Anonymous Referee #1

Overall Review

The manuscript combines two well-known models for infiltration and groundwater flow and the “infinite-slope” approach for analyzing a disastrous landslide event occurred in 2011 in the Umyeonsan mountain in Korea. Despite the importance of the topic, e.g., numerical modeling of landslides and of the specific analyzed event, I fail in recognizing the added value of this study in terms of novelty in the modeling component (see **major comment 1**), as well as the paucity of analysis and discussion of results leaves the reader with the feeling that we cannot learn much from this case study (**major comment 2**). Furthermore, the way the article is written and the content is organized can be largely improved (**major comment 3**).

Figure R1. ROC graph comparing the analysis result for test site 1

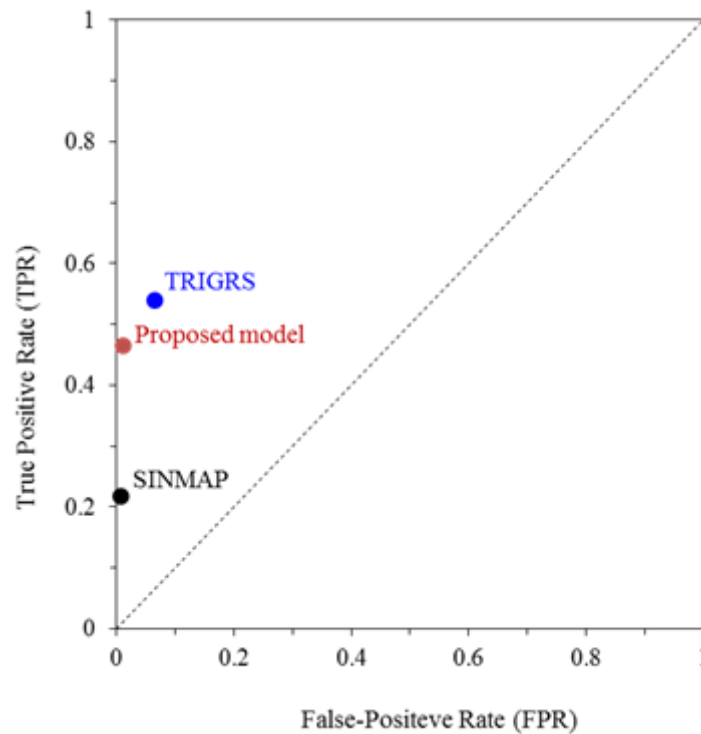
- 2) Another major comment concerns the fact that almost the entire manuscript is dedicated to explain the models or the data. For instance, an excessive length is dedicated to measurements, which are not so important in this article. There is very little space for the results, which will be the most interesting part. Results are marginalized in one page (pp 5586-5587) and in Figure 8 only. Much more can be done in terms of data analysis starting with some rigorous and serious statistical comparison of model results with landslide observations, computing false positive, false negative, true positive, and true negative predictions and using for instance ROC (Receiver Operating Characteristic) curves (Frattini et al., 2008, 2010; Nefeslioglu et al., 2008). Furthermore, more discussion is needed, why somebody should use the approach the authors presented rather than other approaches, which are the advantages and disadvantages? How it is expected to perform beyond the presented case study? Otherwise, the study will remain very limited.

Much emphasis was not given in comparing with existing models. Provided the Figure R1 below shows ROC CURVE which had been compared in preliminary study. The objective of this study is to detect two types of landslides. Thus analyzing the ROC curve, even though it is known to be effective in accessing landslide model performance, was not necessary at the time.
